STATE OF MAINE
DEPARTMENT OF TRANSPORTATION
16 STATE HOUSE STATION
AUGUSTA, MAINE 04333-0016

December 29, 2022
Subject: Acadia Gateway
State WIN: 017163.03
Location: Trenton
Amendment No. 3

ACADIA GATEWAY FACILITY

INTERMODAL AND WELCOME CENTER

SEPTIC TANK NOTES:

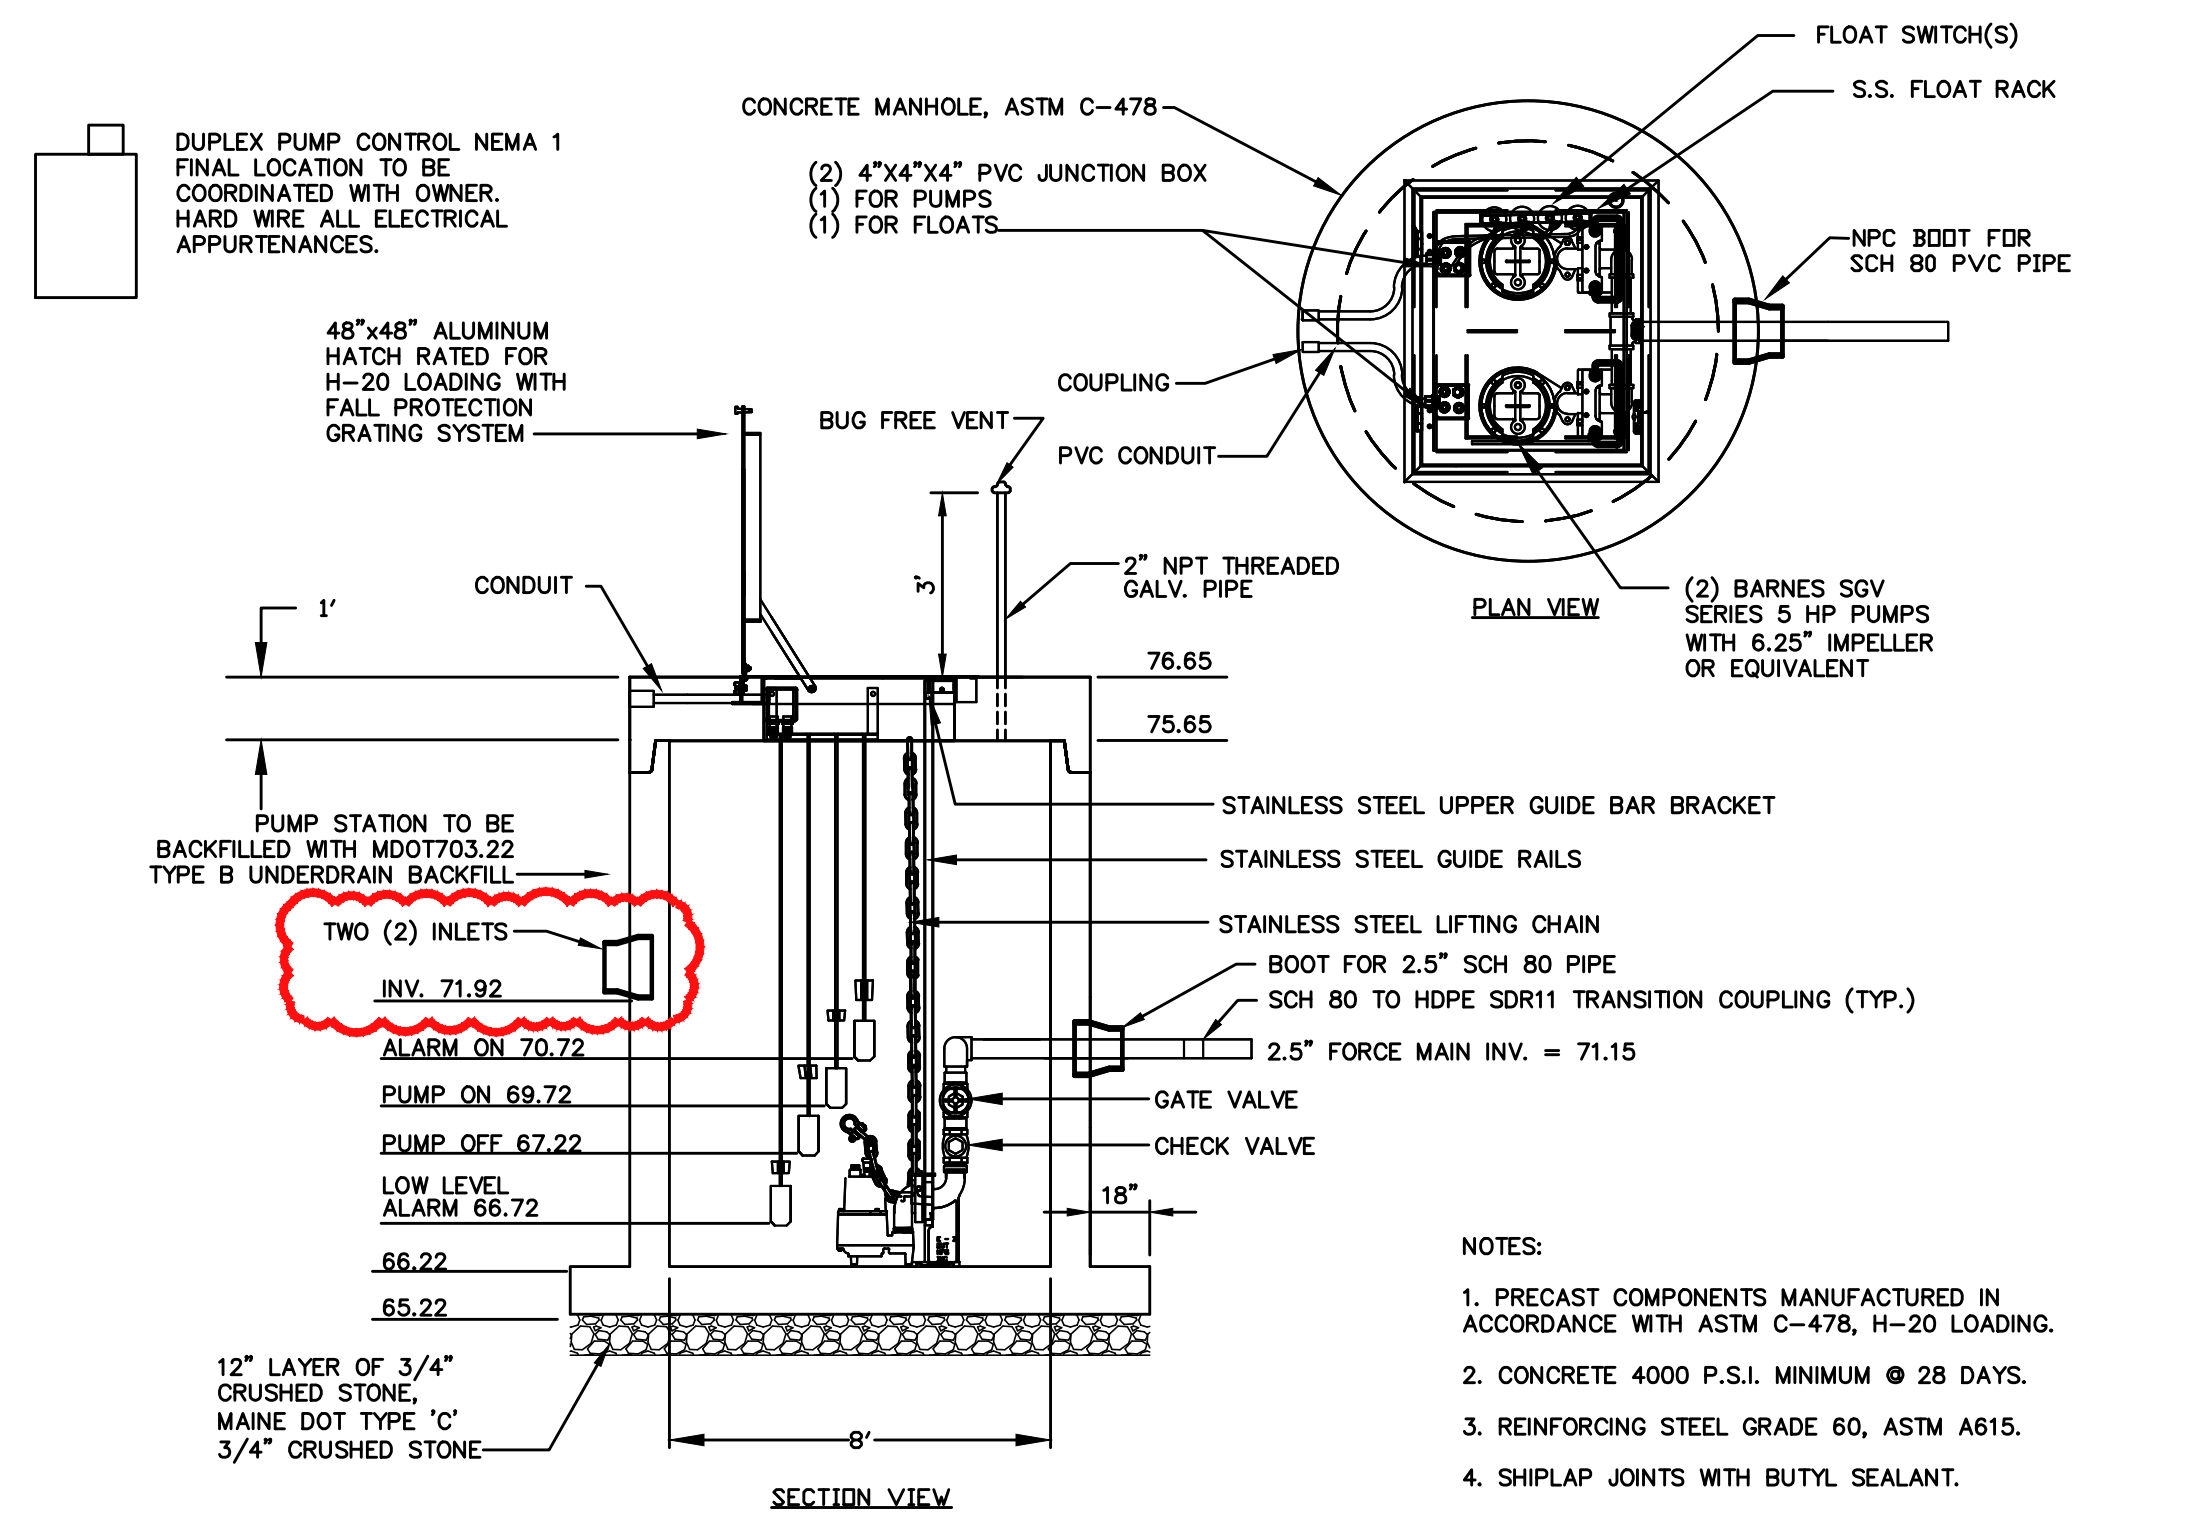
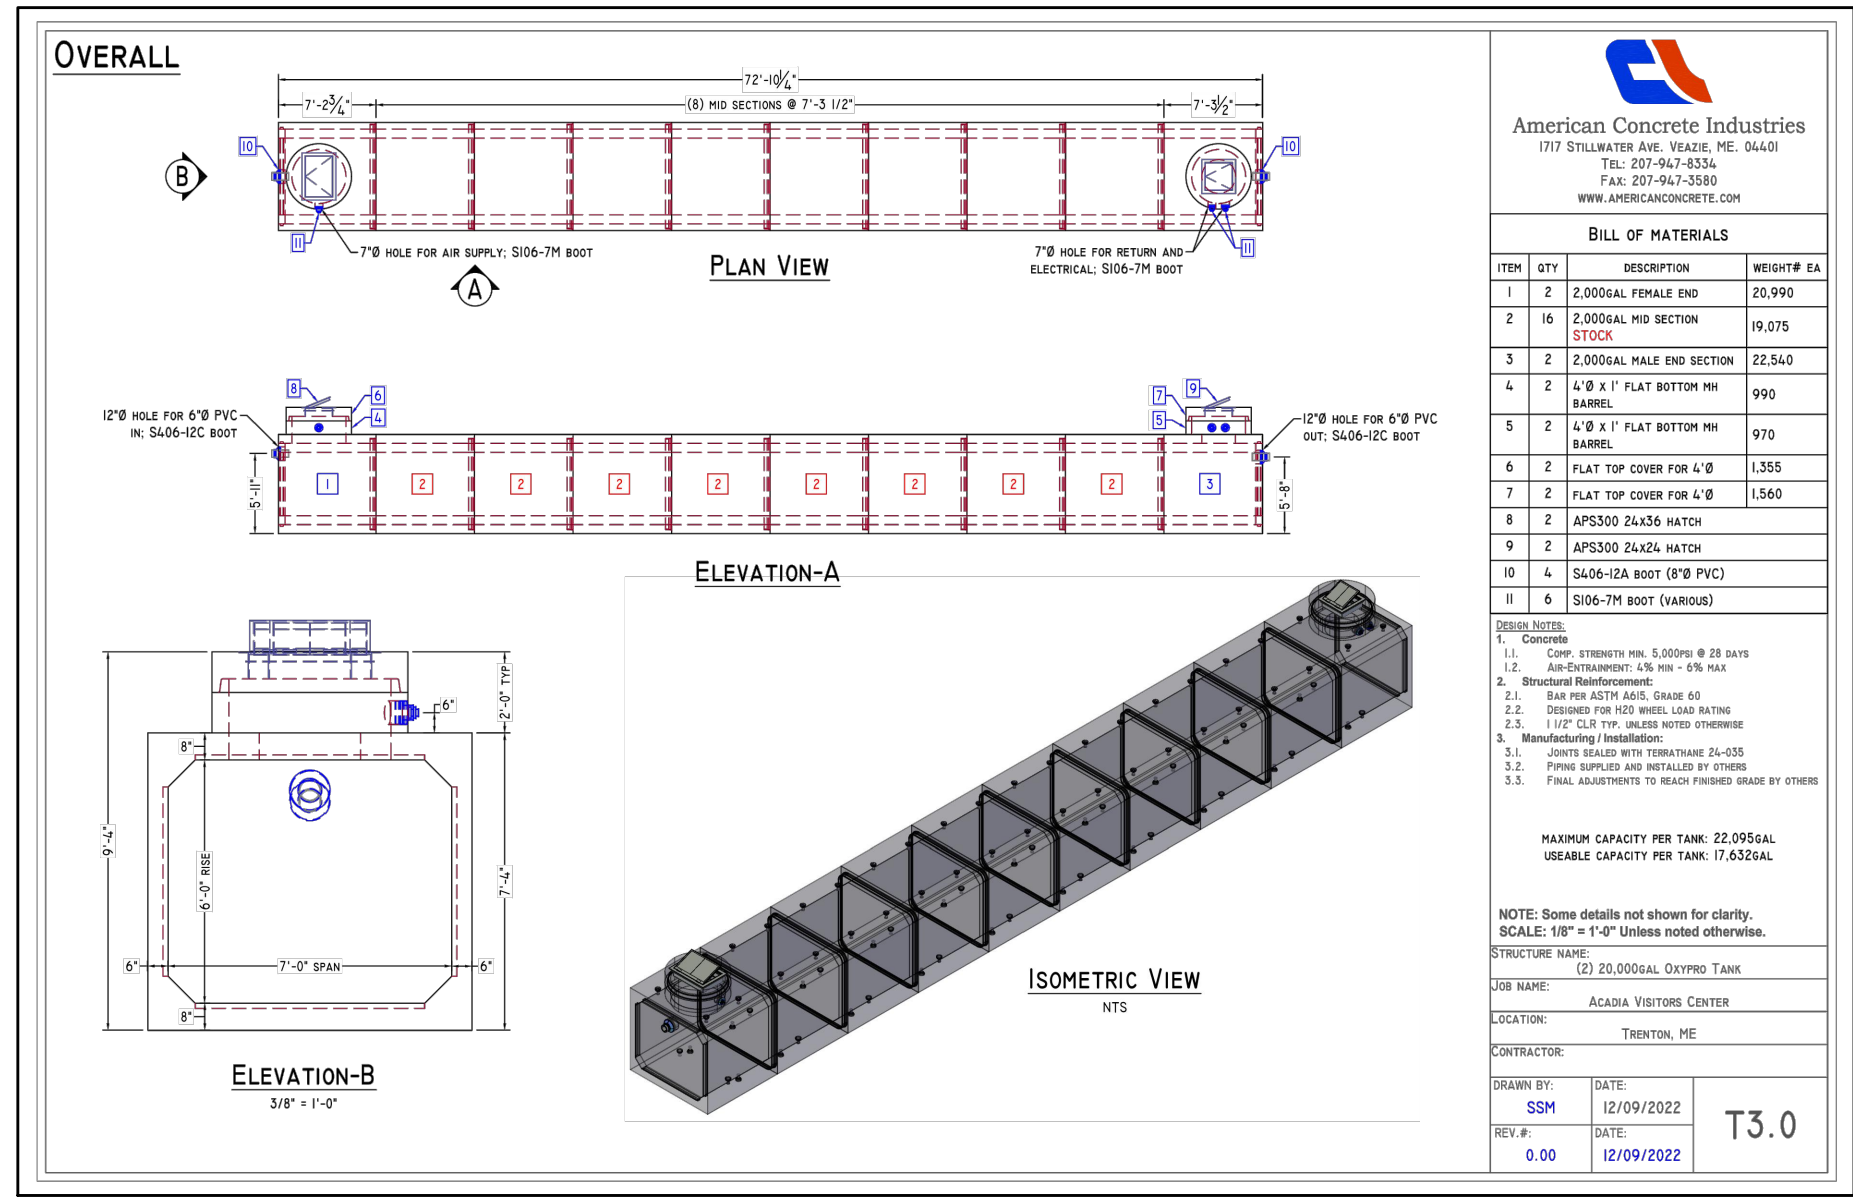
AMENDMENT #2 REVISIONS:
- REVISED SEPTIC DETAILS

1 Unit Pavers on Bit Conc
Scale: 1" = 1'-0"

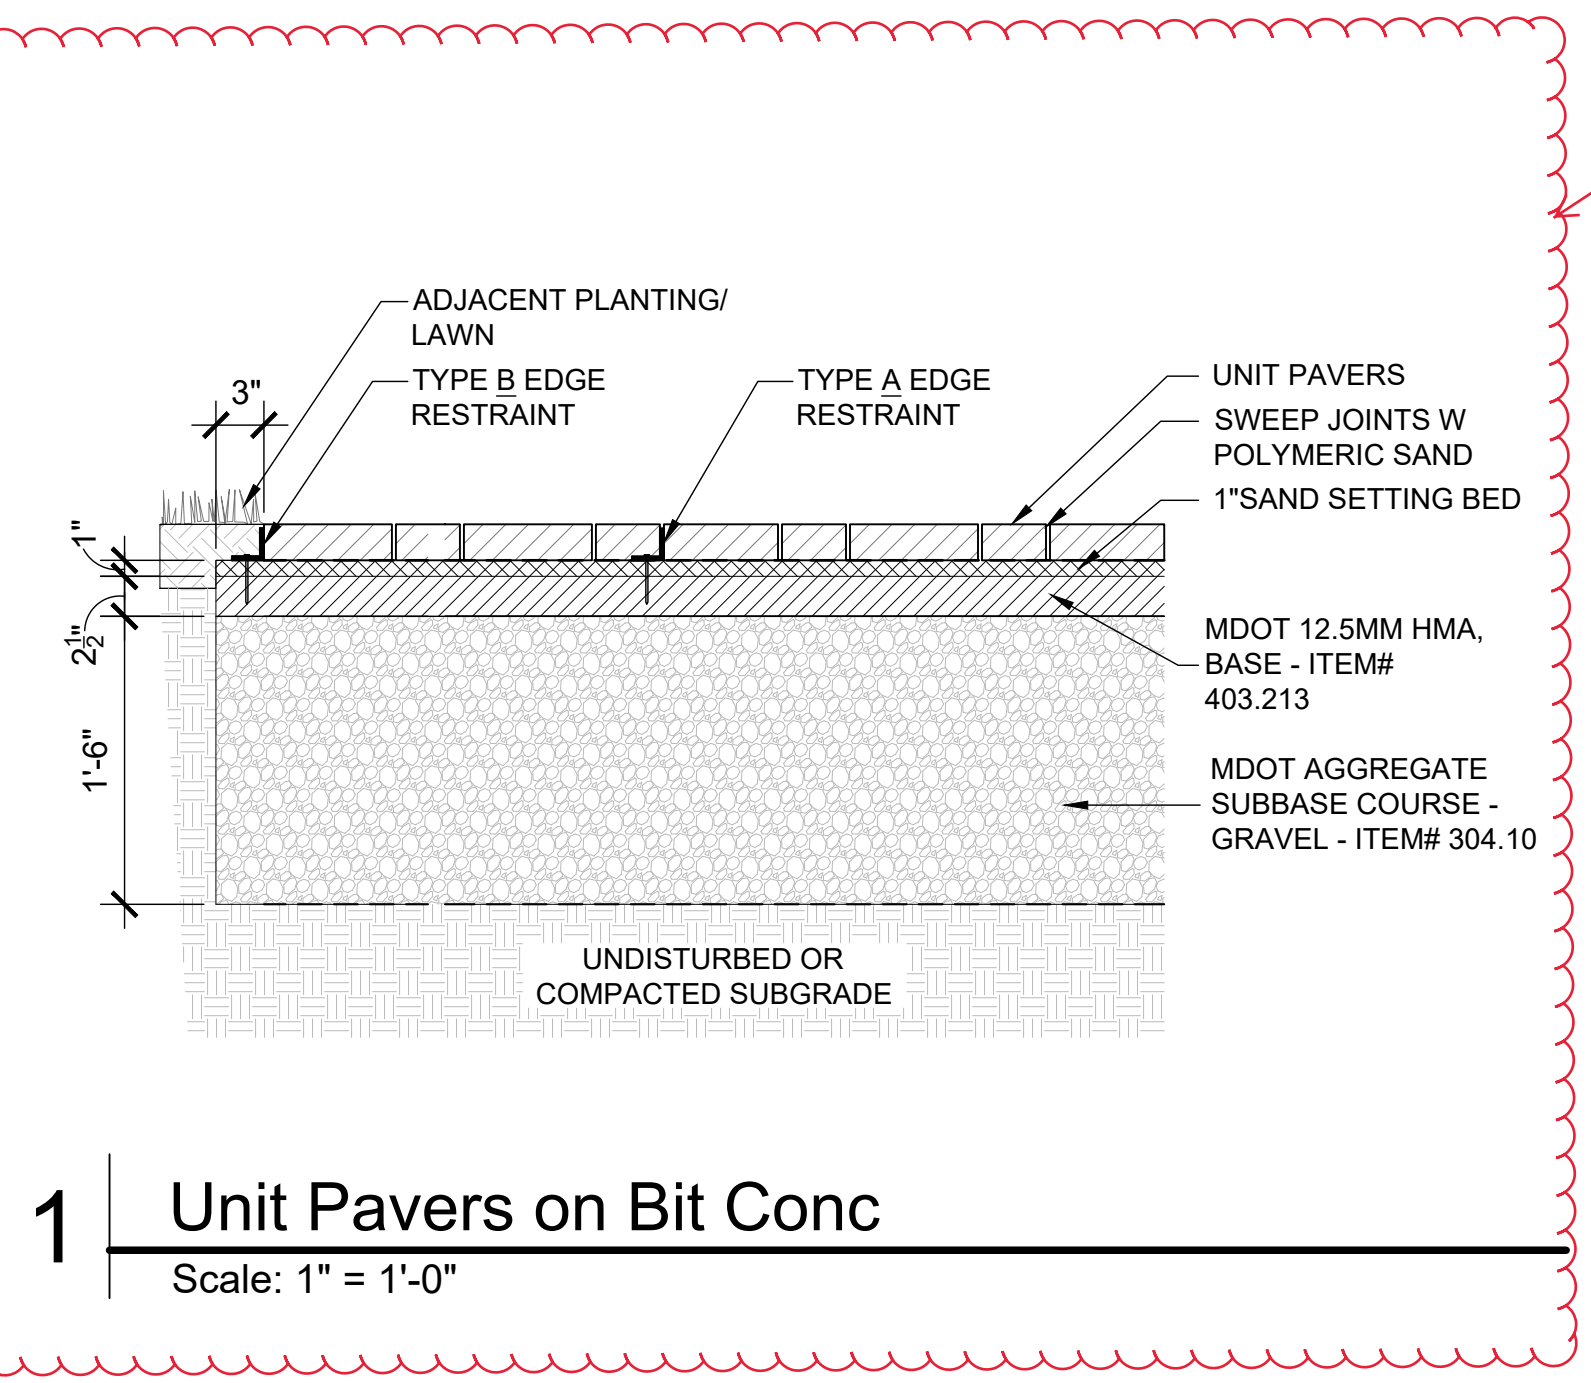
Question: Detail 1/L301 calls for a "SAND SETTING BED" as well as a "BIT CONC SETTING BED". Which is the correct paver setting bed?

Addendum #2
Eliminate reference to
Bit. Conc. Setting Bed

Response: The correct setting bed is 1" sand setting bed over a bit conc base. This is what is specified as well. Updated drawing L301 is included as part of Amendment #3.

5 Bike Rack
Scale: 1/2" = 1'-0"

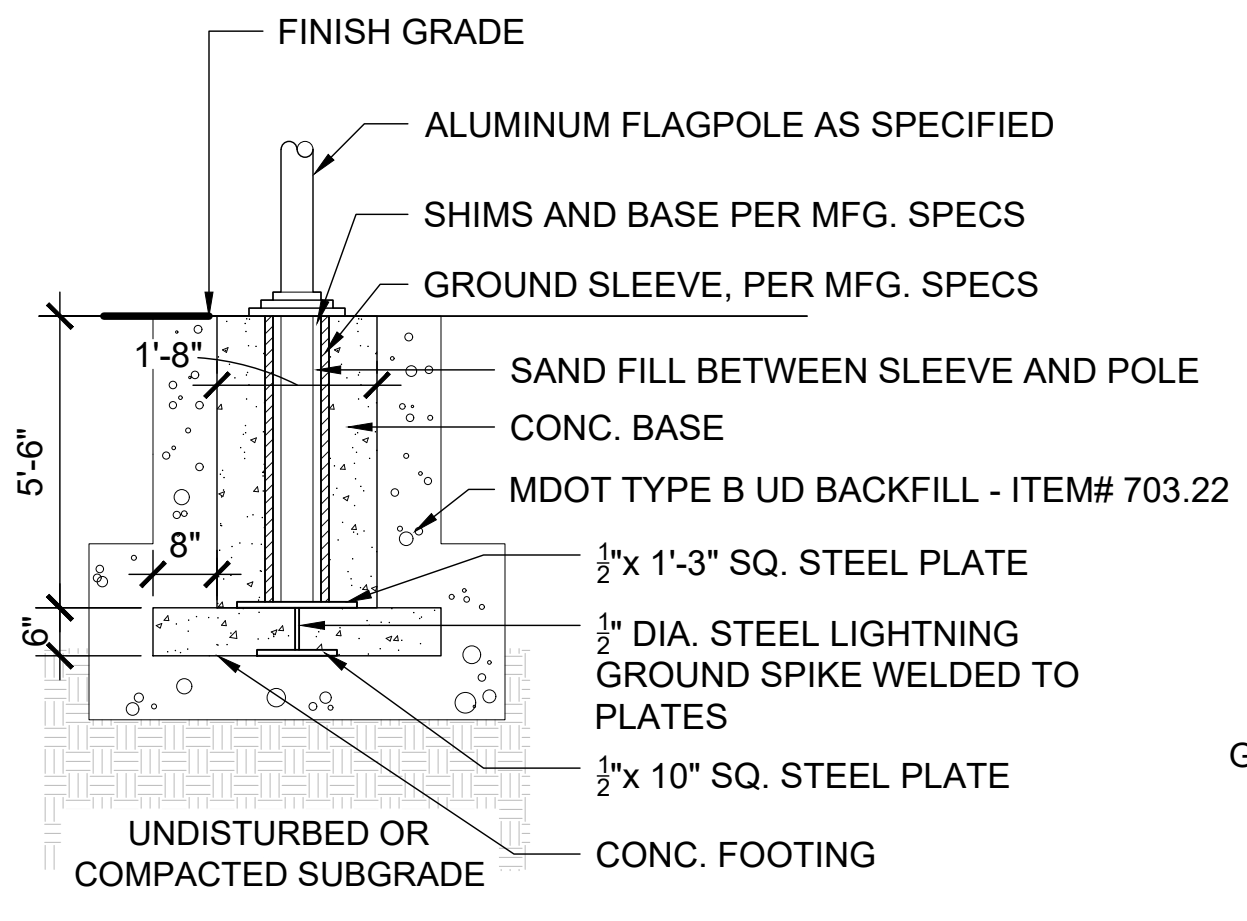
Question: Drawing L101 calls for a "Turfstone Vehicle Turnaround" referring to detail 5/L301. This detail refers to the Bike Racks. I do not see another detail or specification for Turfstone. Please clarify.

Response: Drawing L101 has been updated as part of Amendment #3 to eliminate the turfstone. The vehicle turnaround will be bit conc.
